# CITY OF ALBUQUERQUE

**Re:    Mountain Mahogany Community School PH II, 5014 4<sup>th</sup> St NW,  
Request for Permanent C.O. –Accepted  
Engineer's Stamp dated: 03-01-12, (F14/D062)  
Certification dated: 07-12-12**

**Re: Mountain Mahogany Community School, 5014 4<sup>th</sup> Street NW**  
**Grading and Drainage Plan**  
**Engineer's Stamp date 3-01-12 (F14/D062)**

**Re: Mountain Mahogany Community School, 5014 4<sup>th</sup> Street NW, Grading and Drainage Plan**

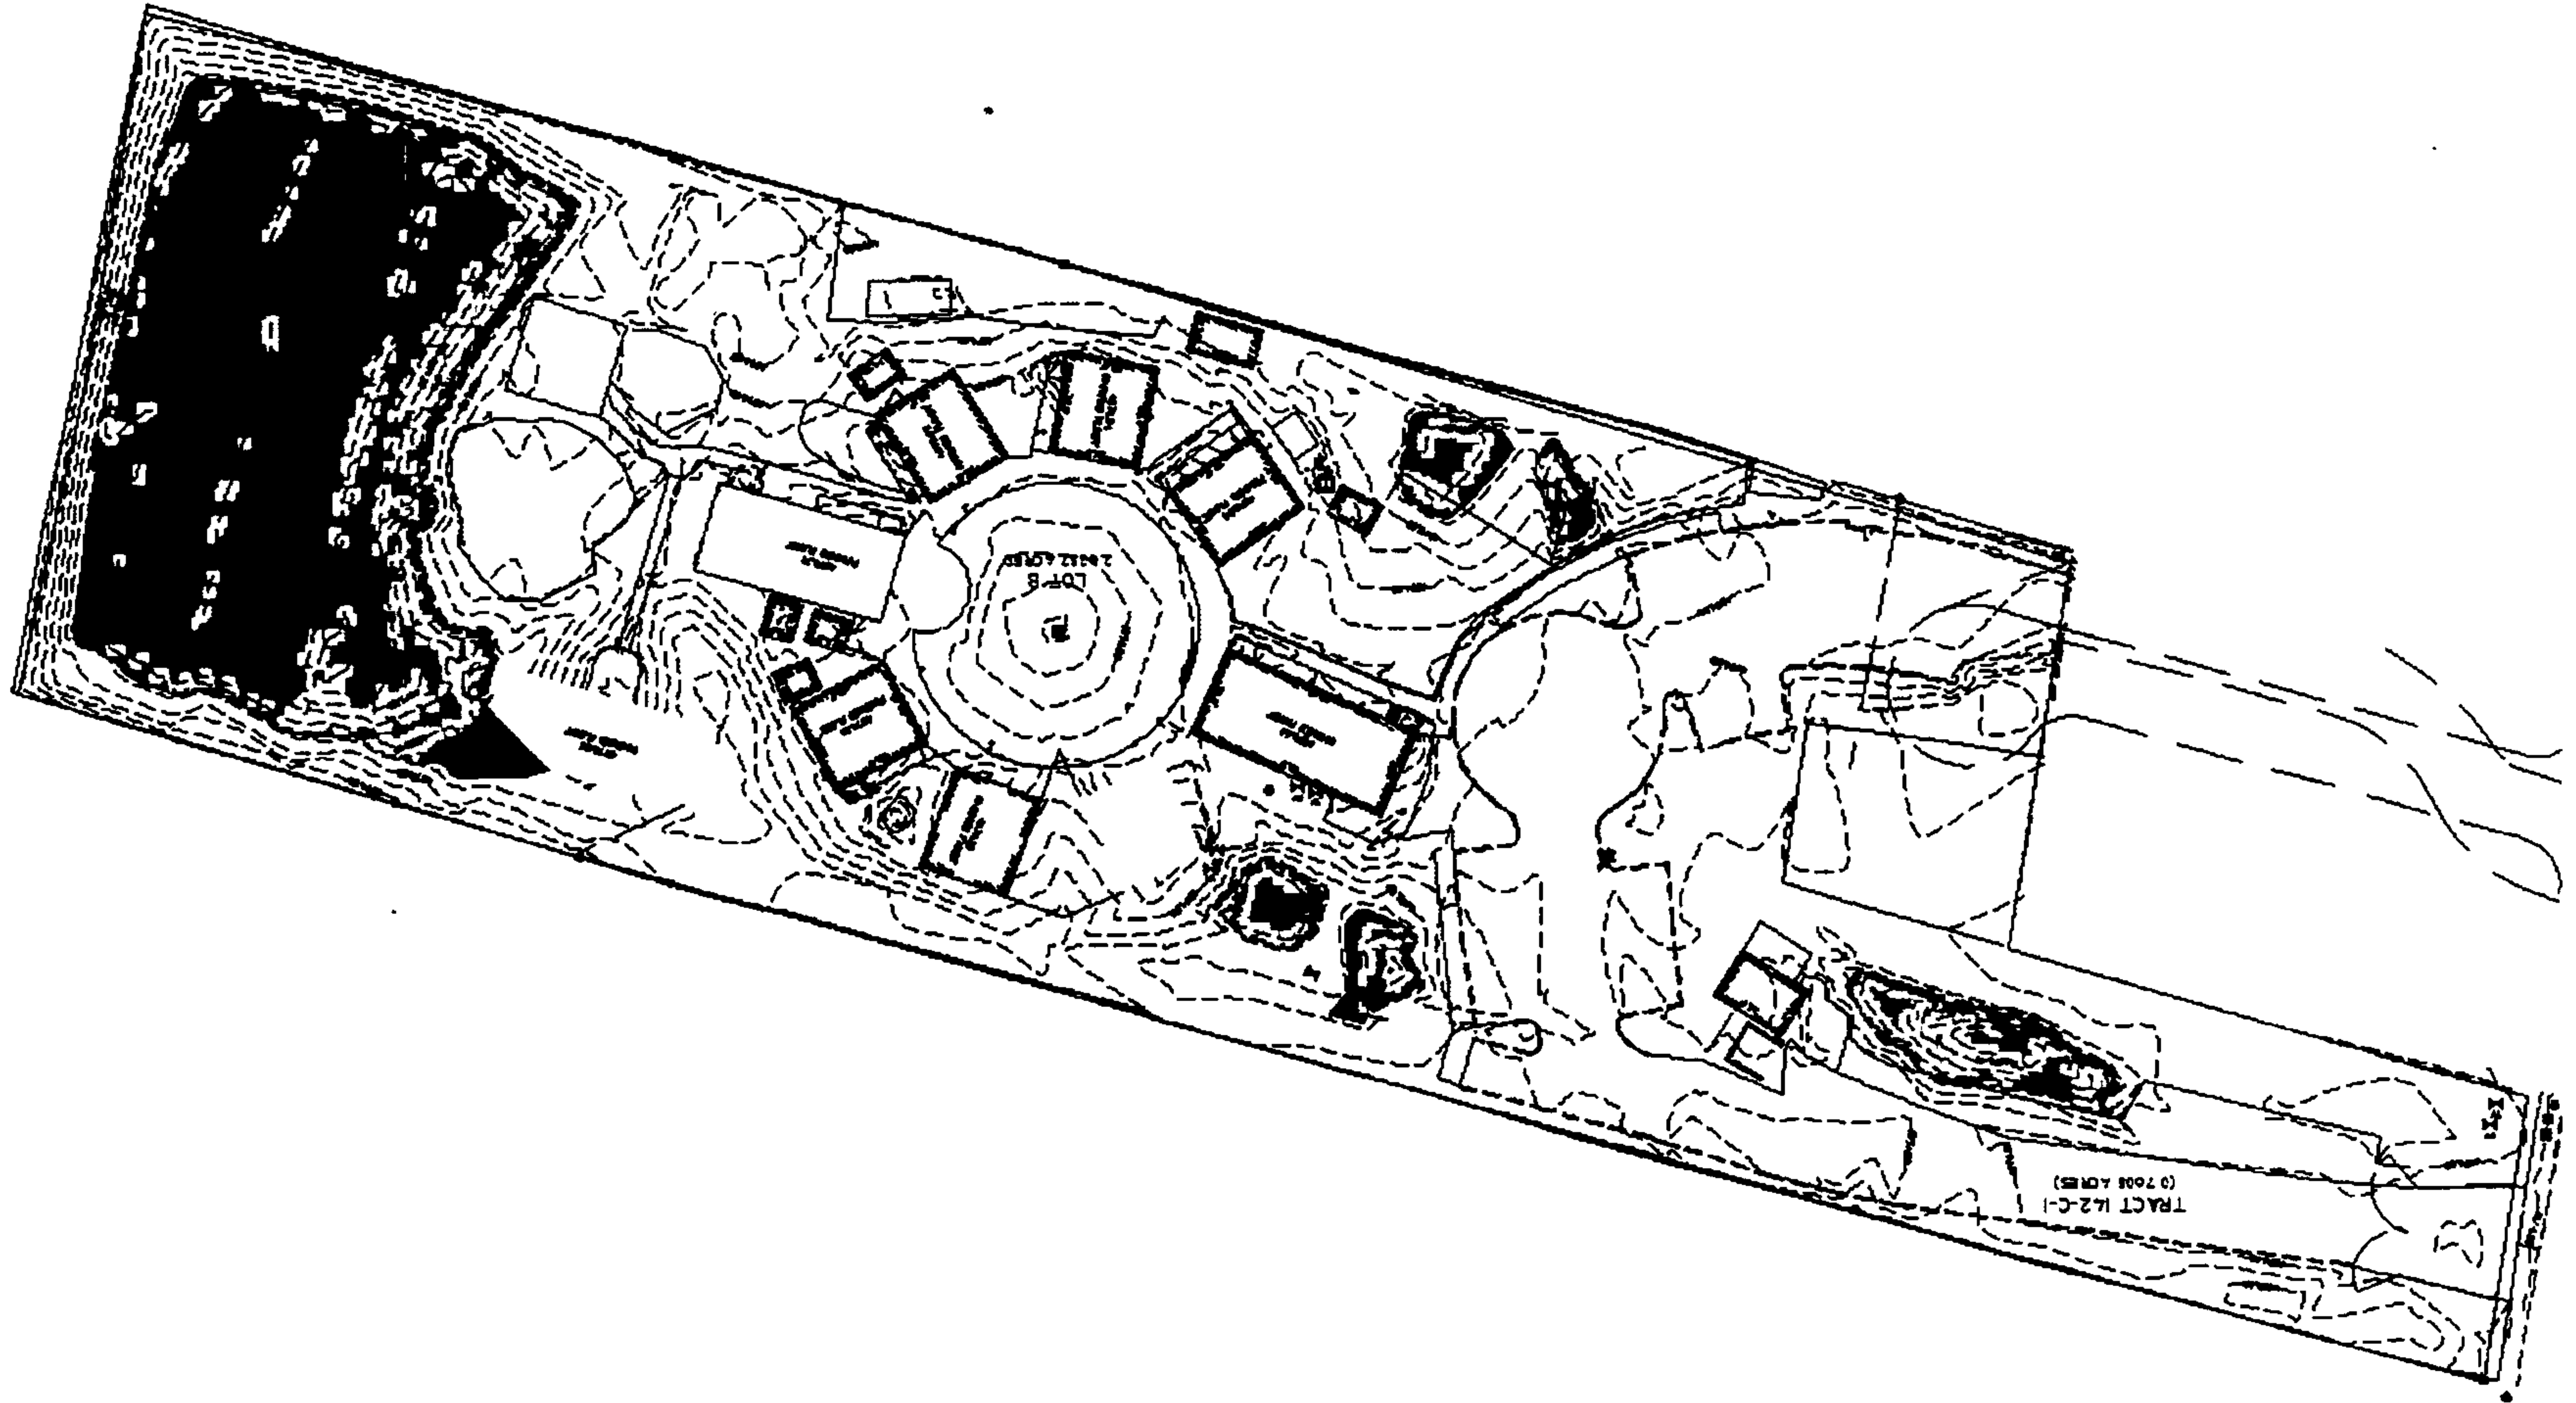
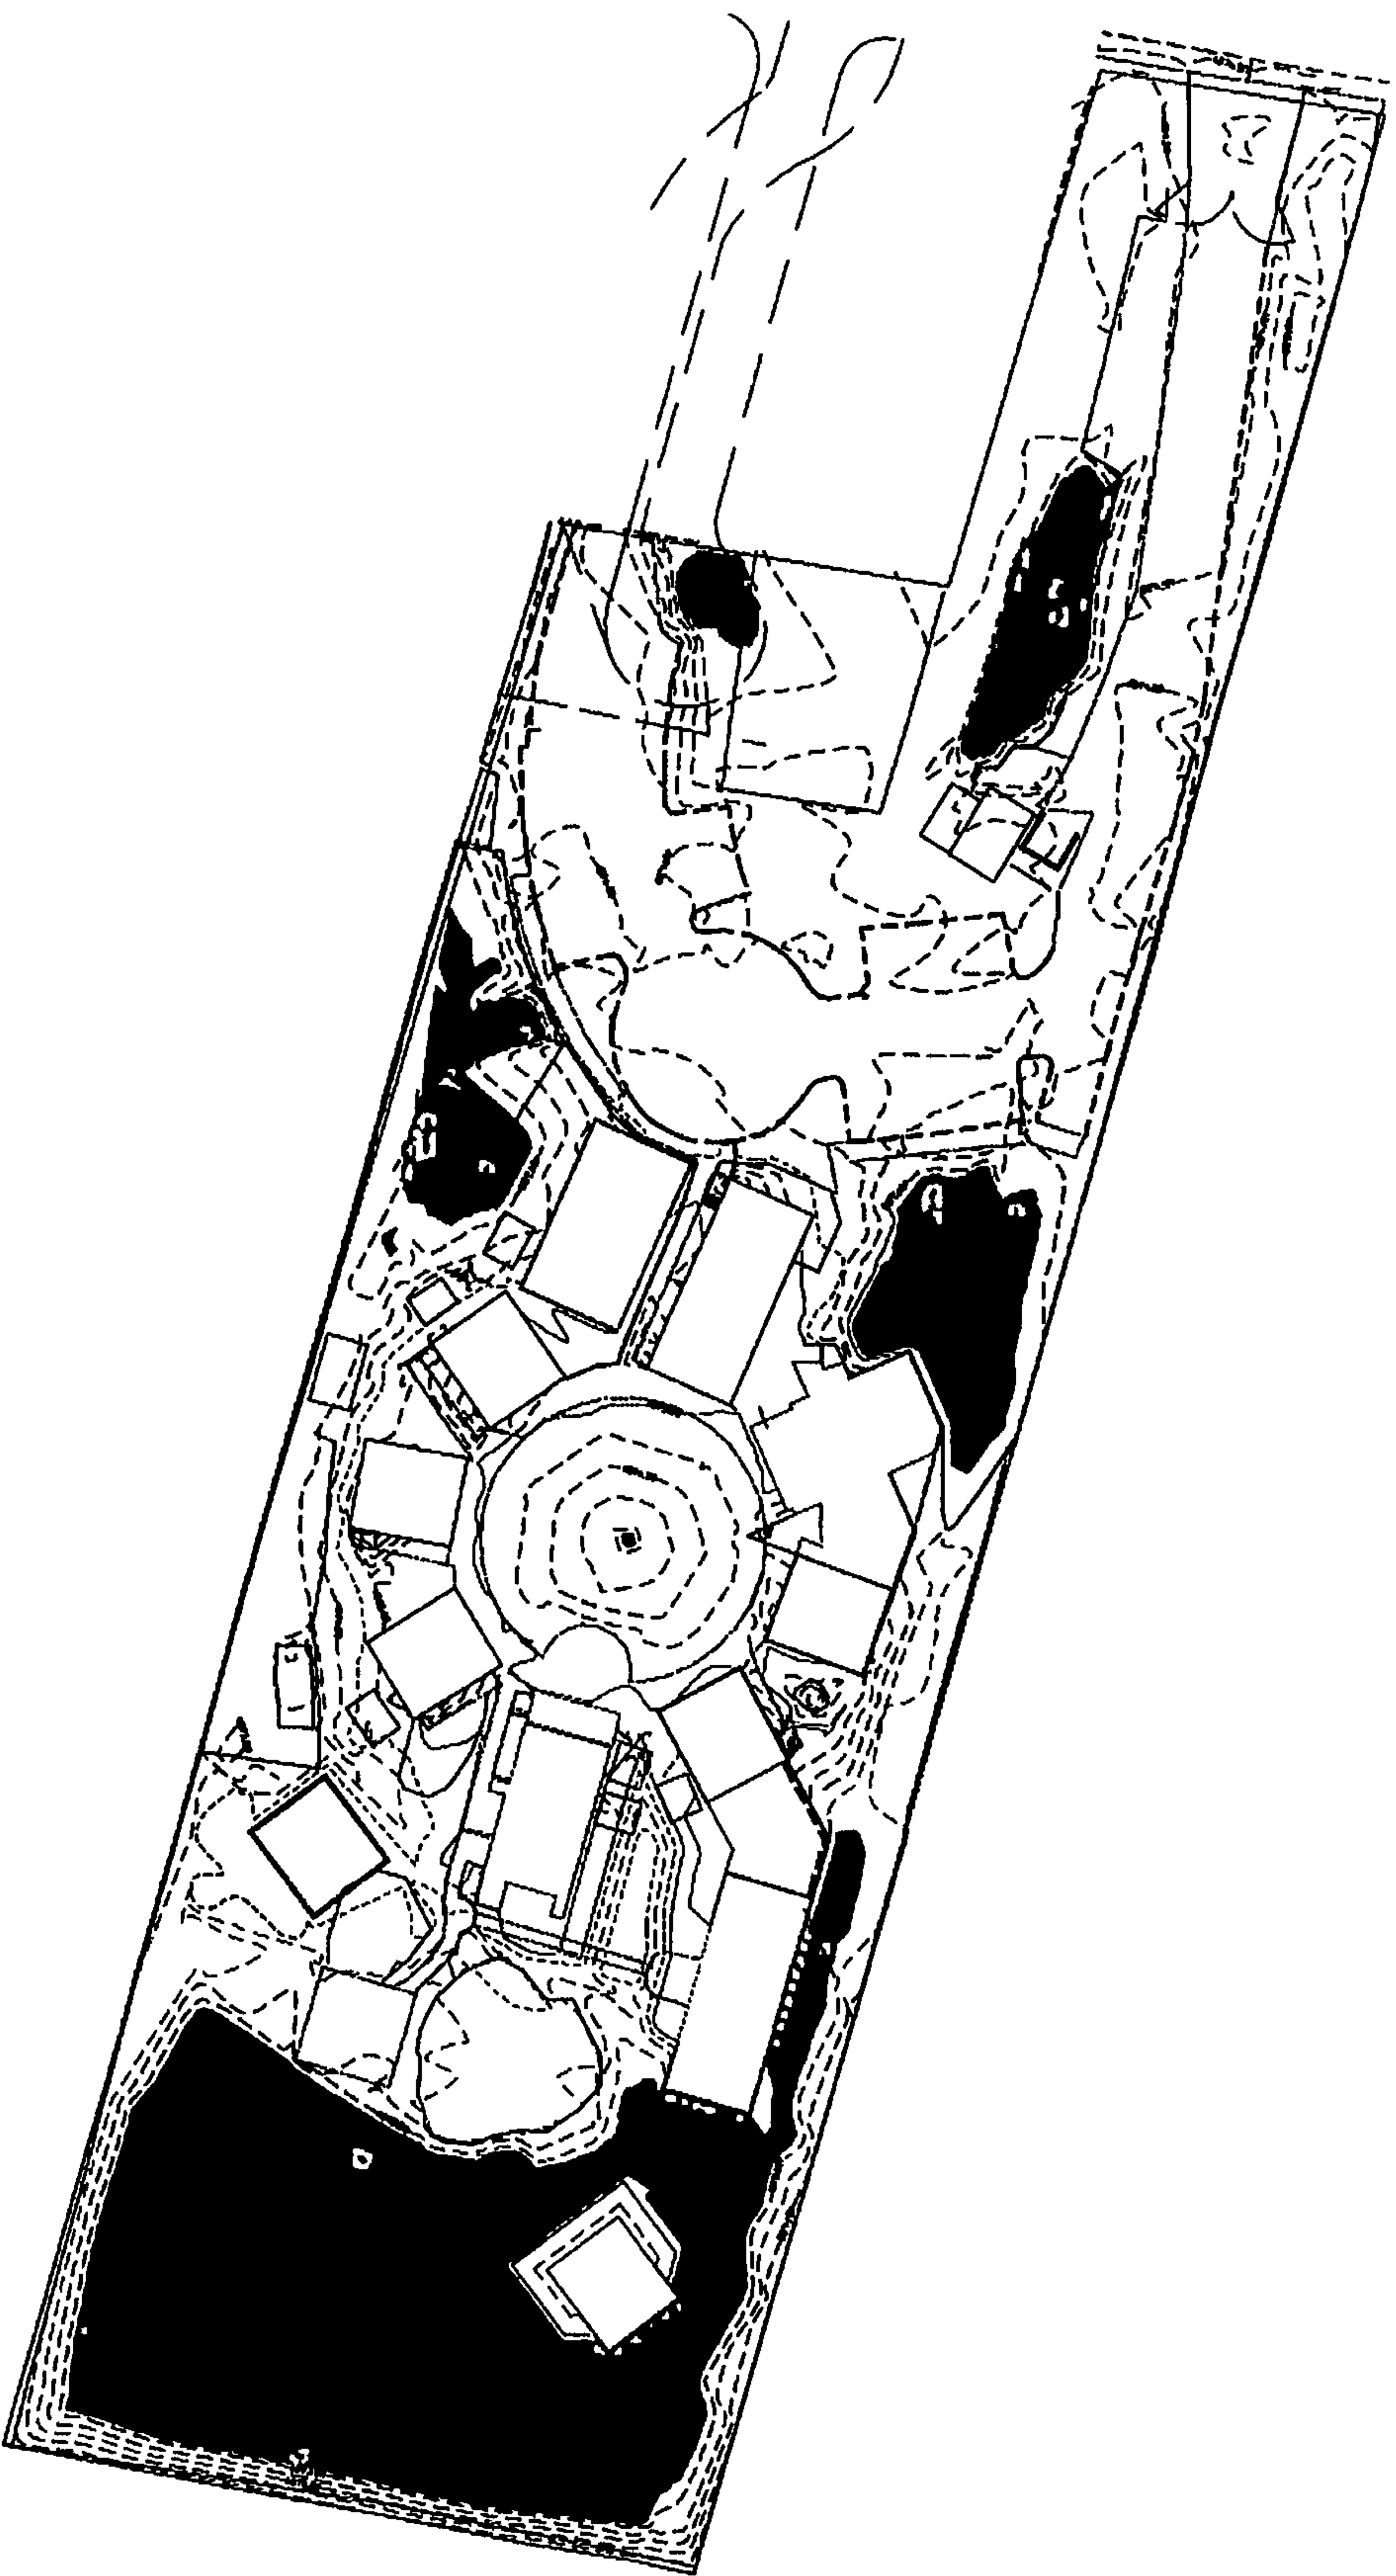
- An approved Grading and Drainage plan is on file for this property and the proposed grading appears to impact the on-site retention ponds that were approved to contain the 100 yr, 10 day storm event.
- One of the existing structures was previously built without a permit and encroaches on one of the approved retention ponds.
- The proposed structures also appear to encroach on another on-site retention pond.
- Provide pond volume calculations to ensure proper water retention is maintained.

Site pond depths were calculated using Civil 3D as follows. A surface was generated based on the provided topographic survey. A second surface (a level plane) was generated to represent water surface elevation and moved vertically until the required volume was achieved. See the attached Volume maps for the portions of ponding .

Existing Conditions (32.8% impervious):  
Required 100-year 10-day volume = 22,535 CF = 835 CY  
Water Surface Elevation = 4972.4

In conclusion, the Mountain Mahogany Charter School site, based on existing topographic survey information, has volume available to store the 100-year 10-day storm event for the proposed condition as well as future additions shown. All of the existing and proposed buildings are elevated at least 2.0' above the future condition water surface elevation of 4972.7.
